SUBJECT: Forwards proposed changes to FSAR Chapter 17.Chapter updated
 to reflect recent organizational changes & info requested by
 NRC.

Subject: Palo Verde Nuclear Generating Station (PVNGS)
Units 1, 2 and 3
Docket Nos. STN-50-528/529/530
File: 84-056-026; G.1.01.10

Attached are proposed changes to Chapter 17 of the FSAR. Chapter 17 has been updated to reflect recent organizational changes, and also includes information requested by the staff in recent telecons.

FIGURE 17.2 - 1

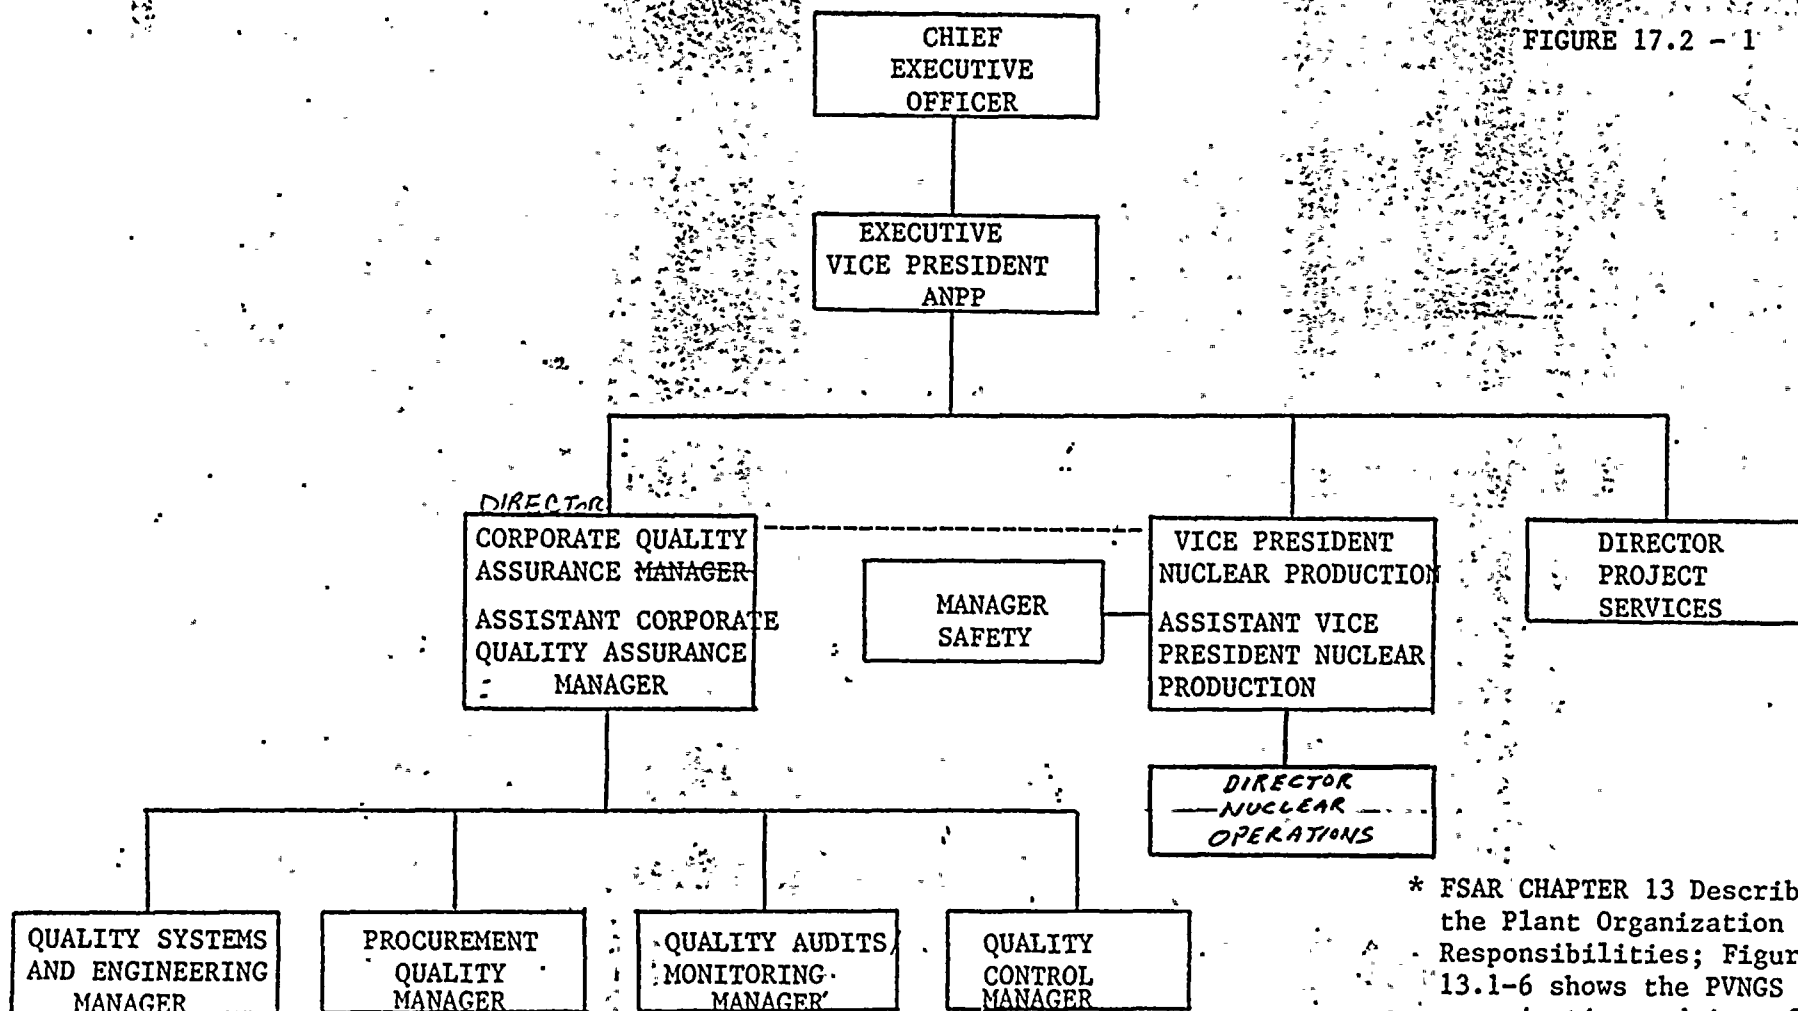
Figure 13.1-4 shows a Site Quality Assurance Supervisor and Site Quality Assurance Personnel reporting to the Quality Assurance Manager. These site personnel are not shown on Figure 17.2.1, and page 17.2-9 indicates the Quality Assurance Department is organized into but two sections. Clarify. Also, discuss the need of the QA Manager to have some full time onsite staff in order to verify effective implementation of the Corporate Operations QA Program.

QUESTION 17A.61 (NRC Question 260.61) (17.2.1)
Section 17.2.1.3.2 indicates the Operations QA Manager "receives functional and technical guidance direction from the Corporate QA Manager", and Figure 17.2-1 has a dashed line between these two positions which the legend indicates as "functional and technical guidance." (Emphasis added)
It is the staff position that the organization shown is acceptable if "guidance" is eliminated from the first quotation and changed to "direction" in the second. Commit to

RESPONSE: Amended sections 17.2.1.2 ~~2~~ and 17.2.1.2.3 describe the ~~Quality Systems Section and Construction QA/QC section as shown~~ ^{CORPORATE QUALITY ASSURANCE DEPARTMENT} in figures 13.1-4 and 17.2-1.

6 RESPONSE: The response is included in amended sections 17.2.1.1.6 and ~~17.2.1.3.2~~ and figure 17.2-1. These responses more correctly define Arizona Public Service Company's Quality Assurance responsibilities.
